## Addendum #1

**Project Name:** NDOR Maintenance Facility  
Chadron, NE  
**SHA Project No.:** 15068  
**NDOR Project No.:** AFE K-503 (Building No. 52501)  
**Issued:** December 19, 2016

**C100**

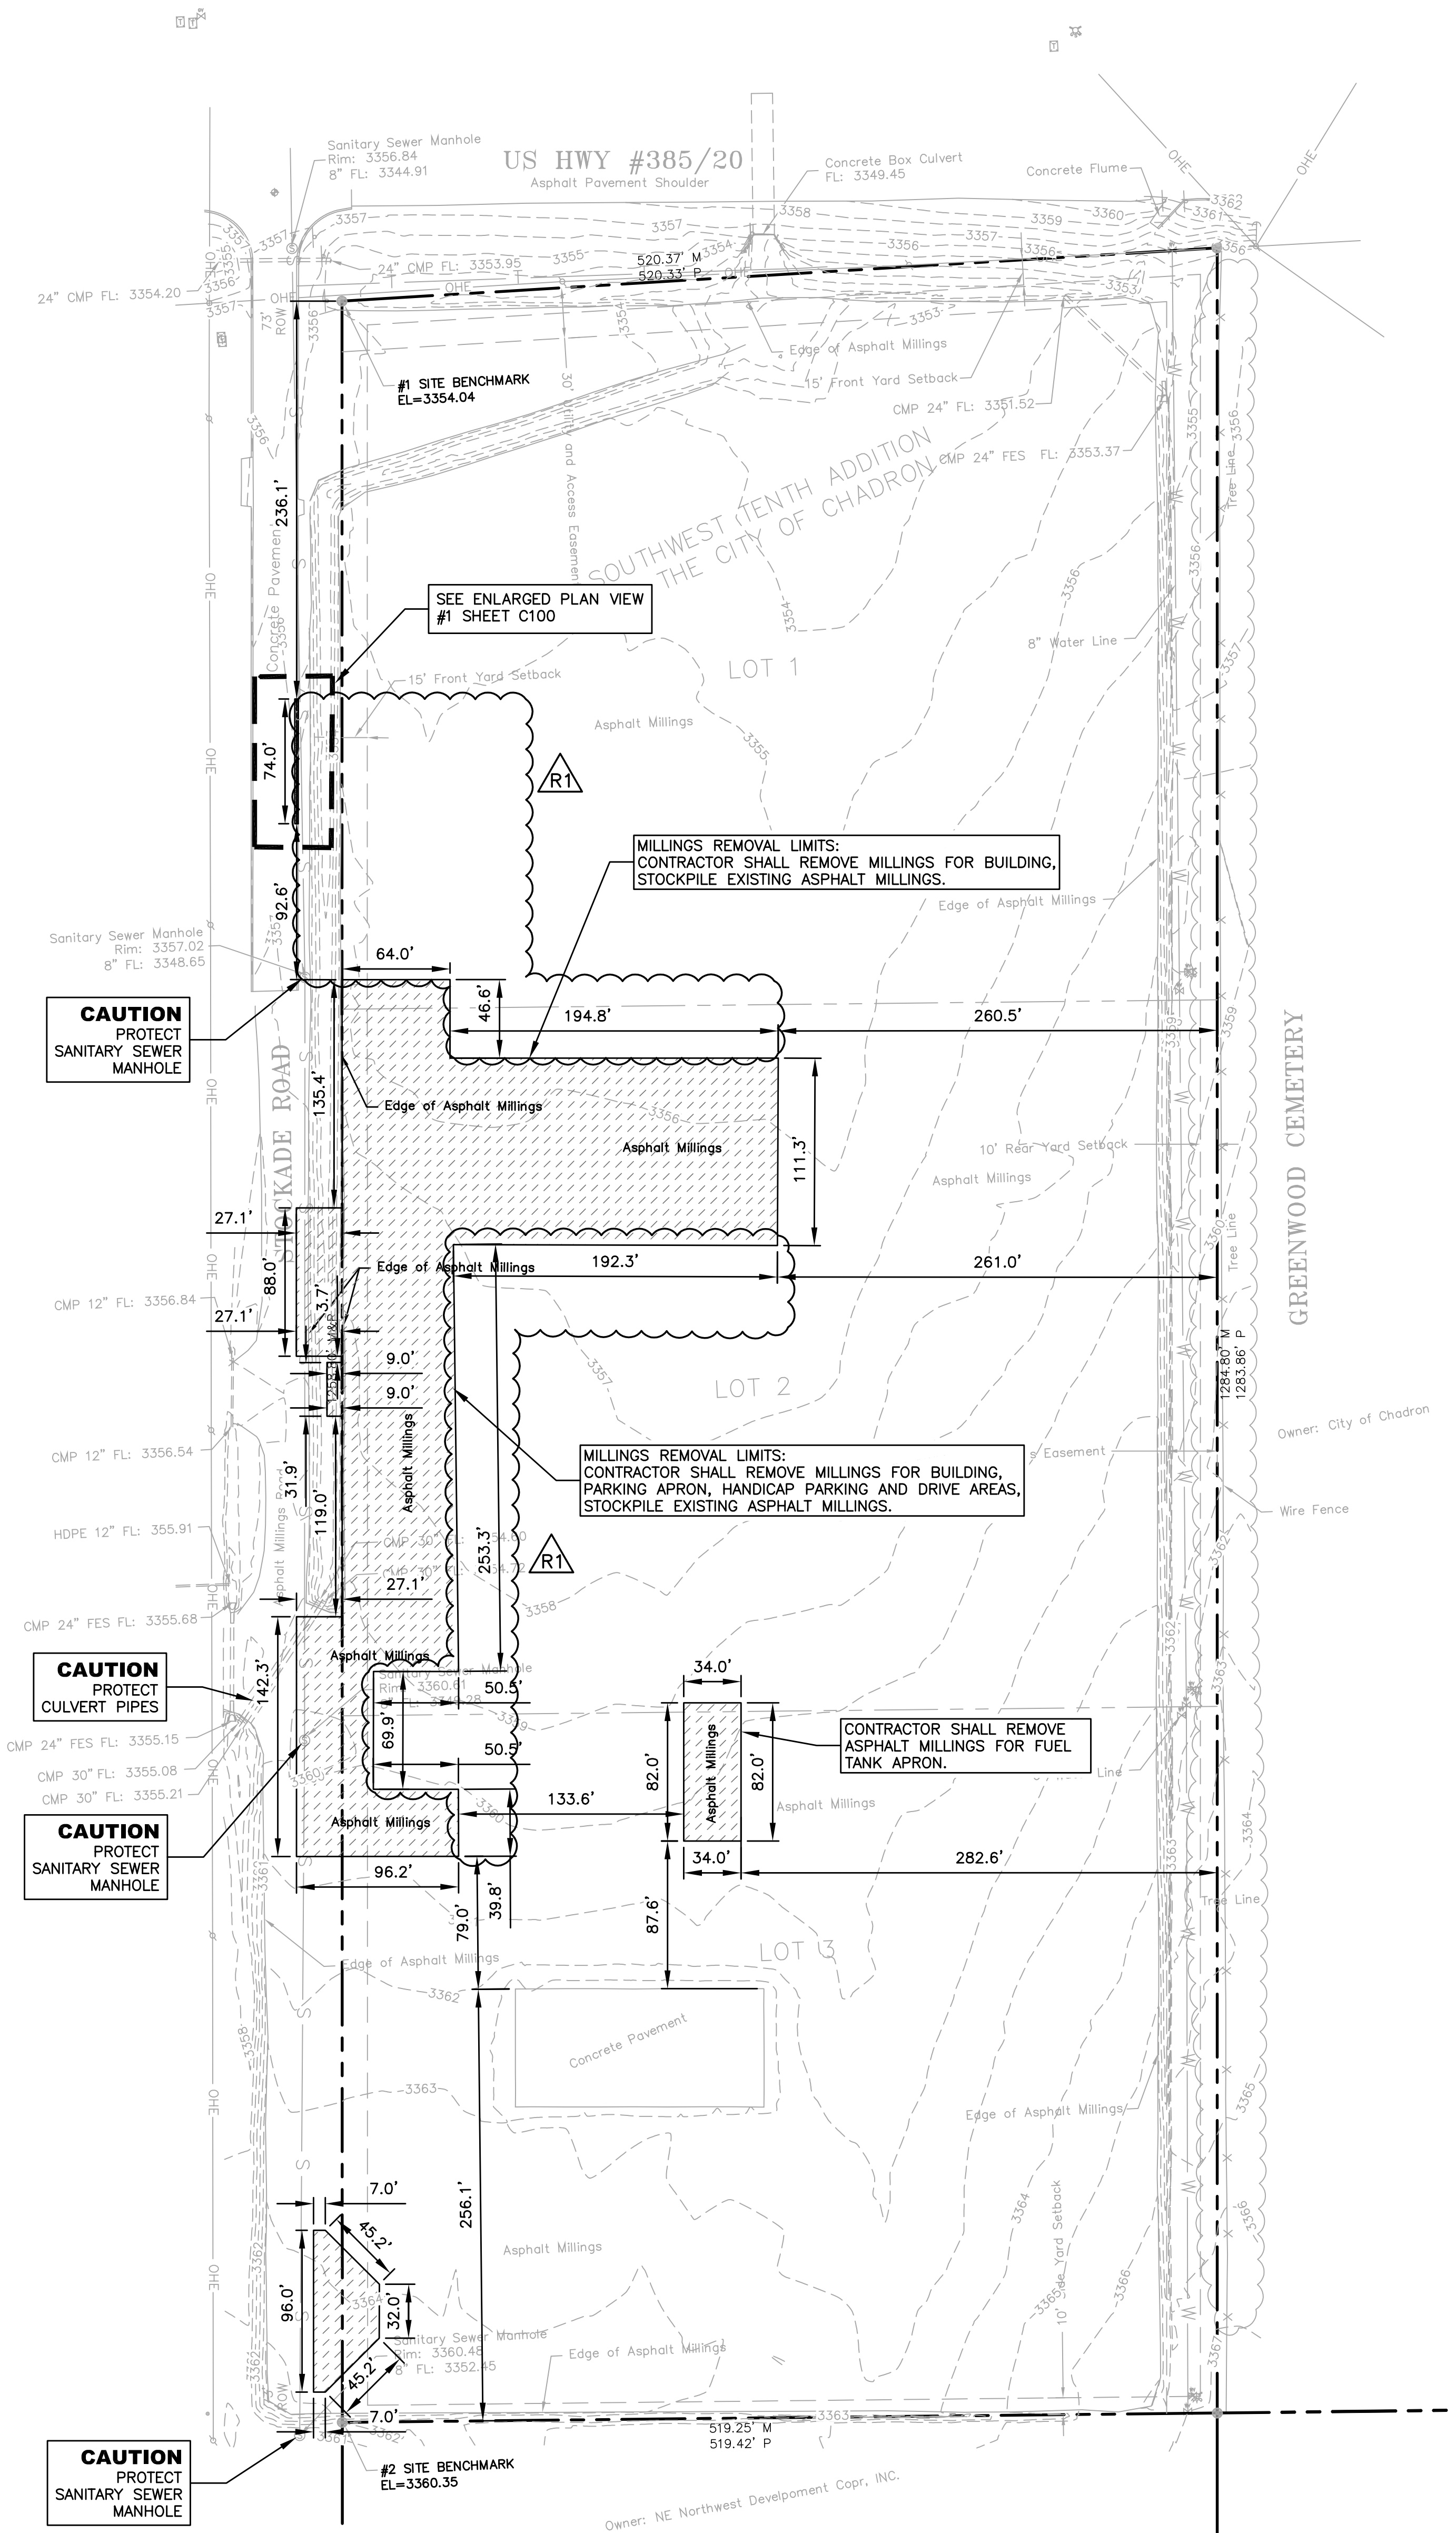
**Response:** Yes. In proposed cut areas, Contractor shall remove millings and soil as needed to ensure 12" asphalt milling depth from proposed final grades.

7. IN PROPOSED CUT AREAS, CONTRACTOR SHALL REMOVE MILLINGS AND SOIL AS NEEDED TO ENSURE 12" ASPHALT MILLINGS DEPTH FROM PROPOSED FINAL GRADES. SEE SHEET C103 FOR FURTHER INFORMATION.

## C103

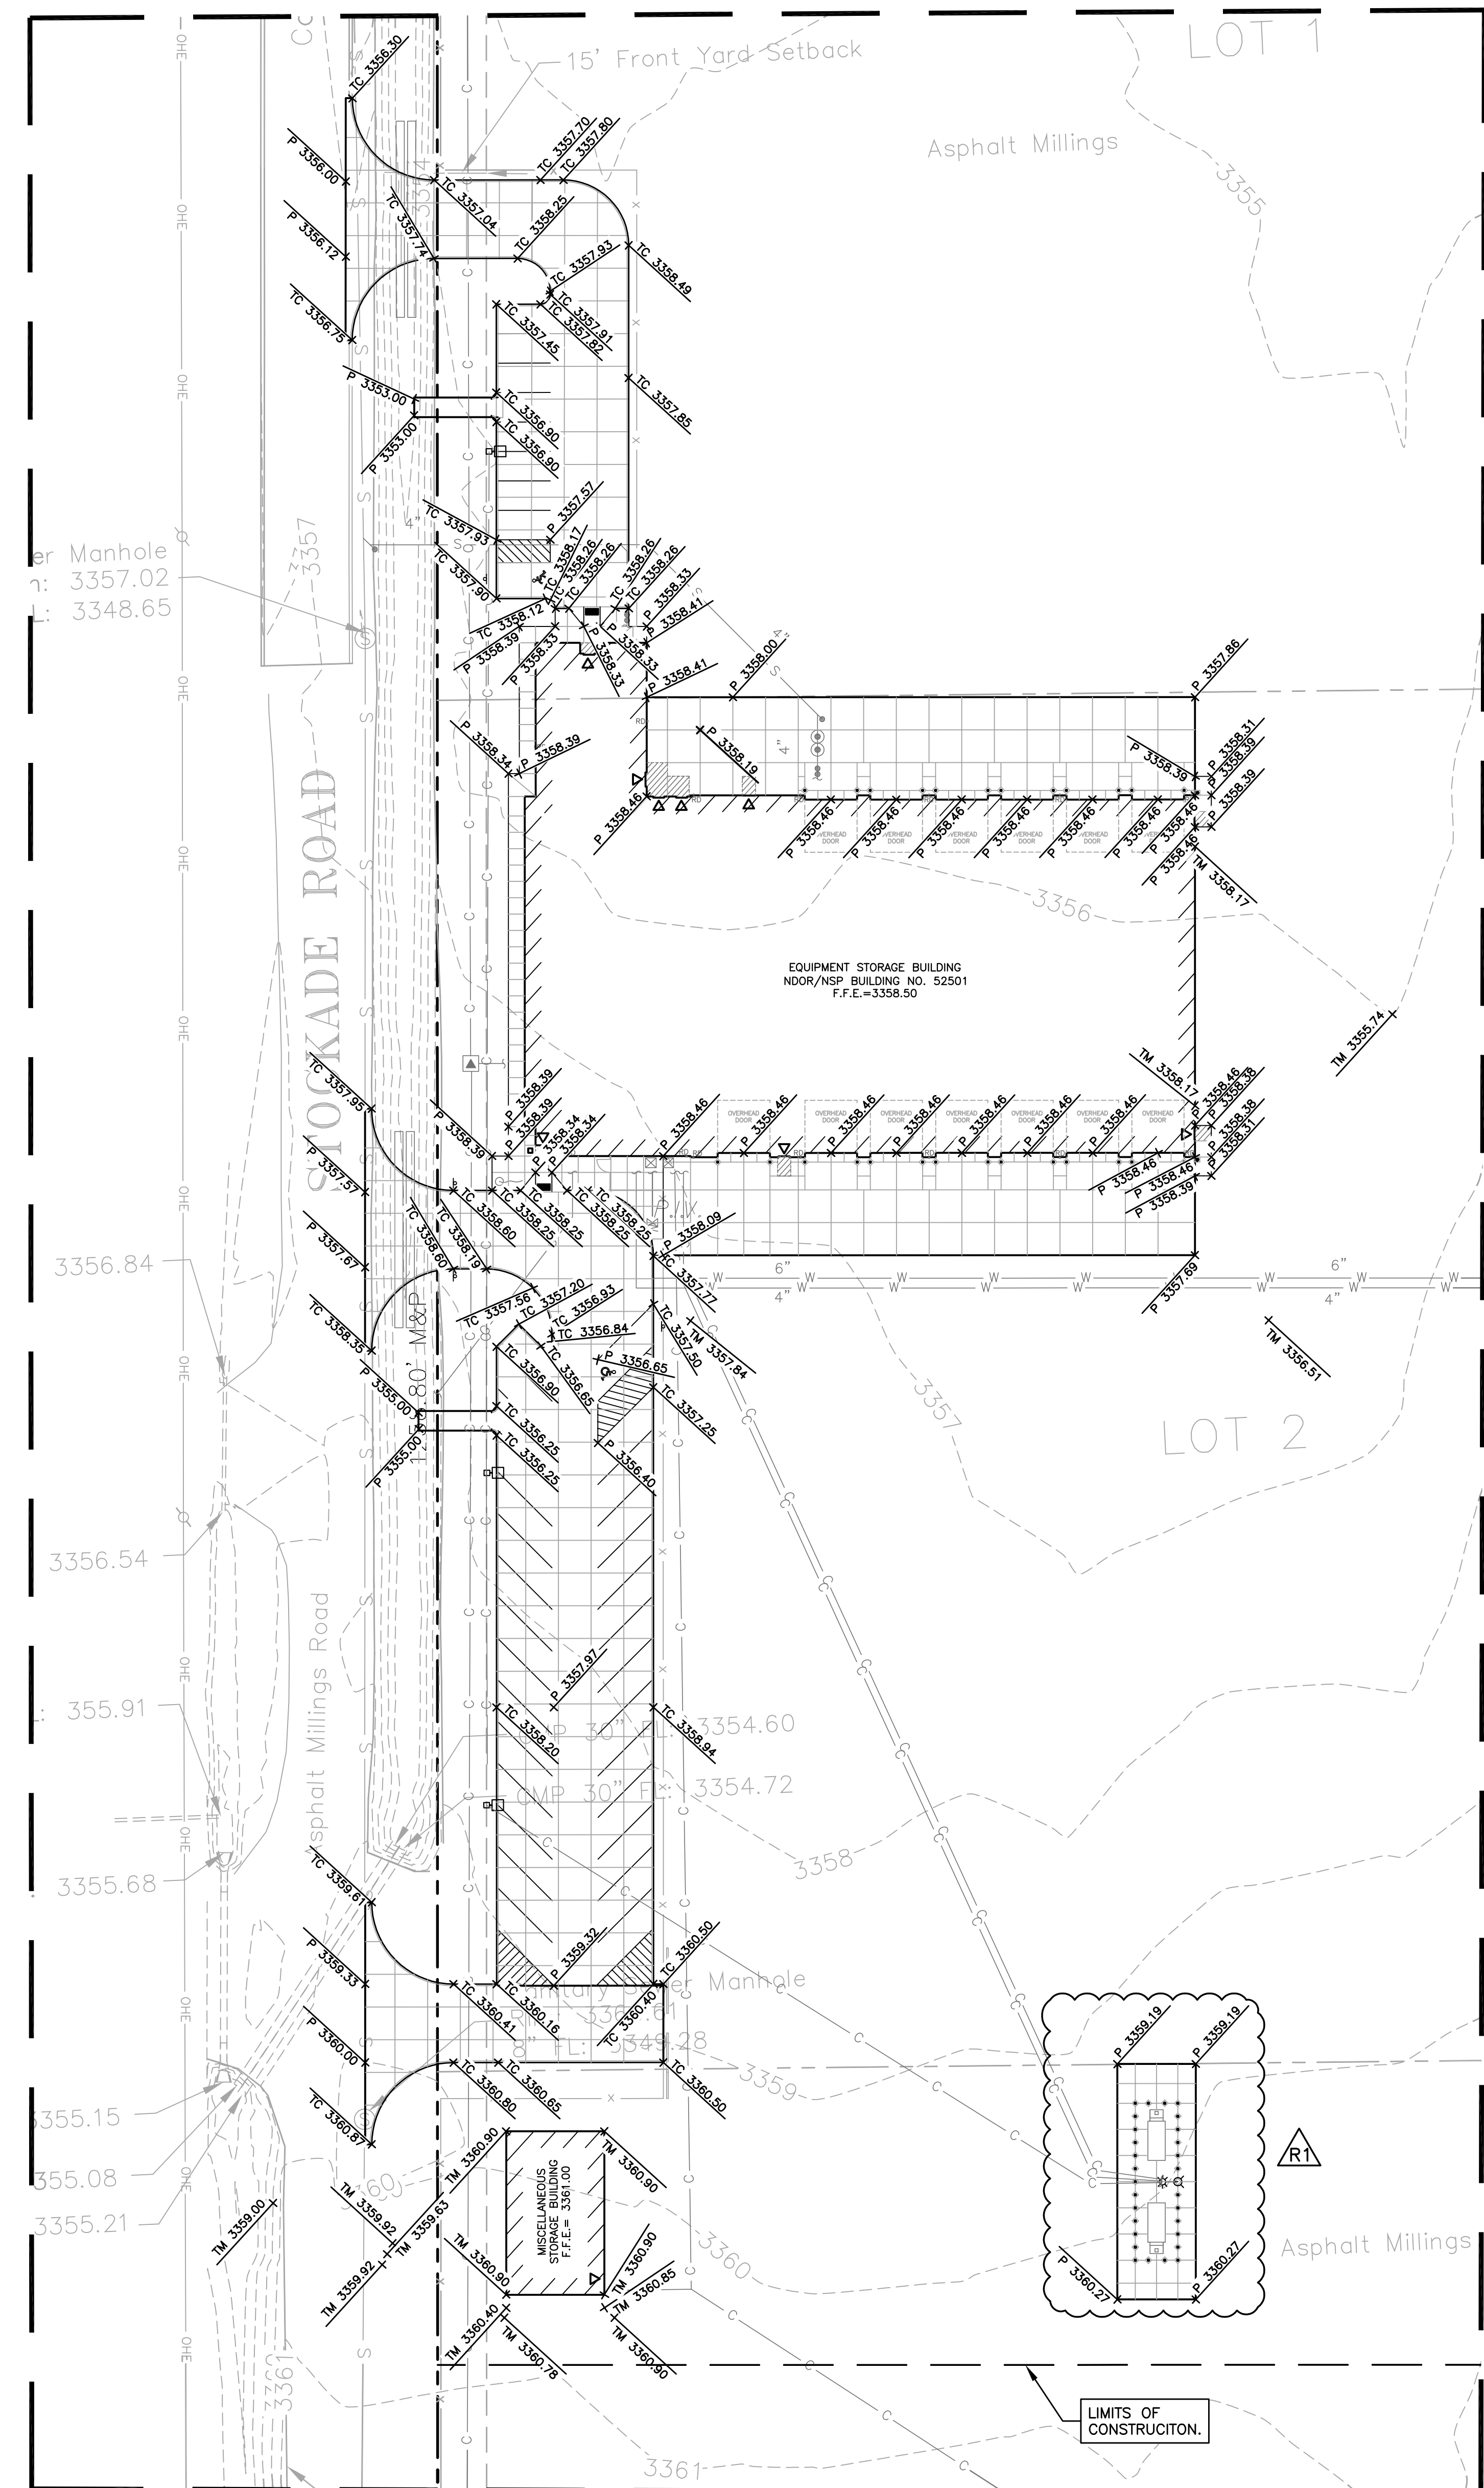
**Response:** Yes. In proposed fill areas, Contractor shall add asphalt millings on top of the existing asphalt millings to achieve the final proposed grades.

- SHEET NOTES:**
1. IN AREAS WHERE ASPHALT MILLINGS ARE TO BE PLACED, CONTRACTOR SHALL BRING SUB-GRADE TO 12 INCHES BELOW FINAL GRADES, AS SHOWN ON THIS PLAN. PLACEMENT OF 12 INCHES MILLINGS TO BE PERFORMED BY NDOR.
  2. ALL DISTURBED AREAS NOT DESIGNATED FOR ASPHALT MILLINGS SHALL BE SEEDED WITH A DROUGHT RESISTANT FESCUE APPROVED BY NDOR AFTER CONSTRUCTION.
  3. ASPHALT MILLINGS ARE ACCEPTABLE AS A BASE OTHER THAN UNDER THE BUILDING.
  4. GUTTER ELEVATIONS ARE 6" BELOW TOP OF CURB UNLESS OTHERWISE NOTED.
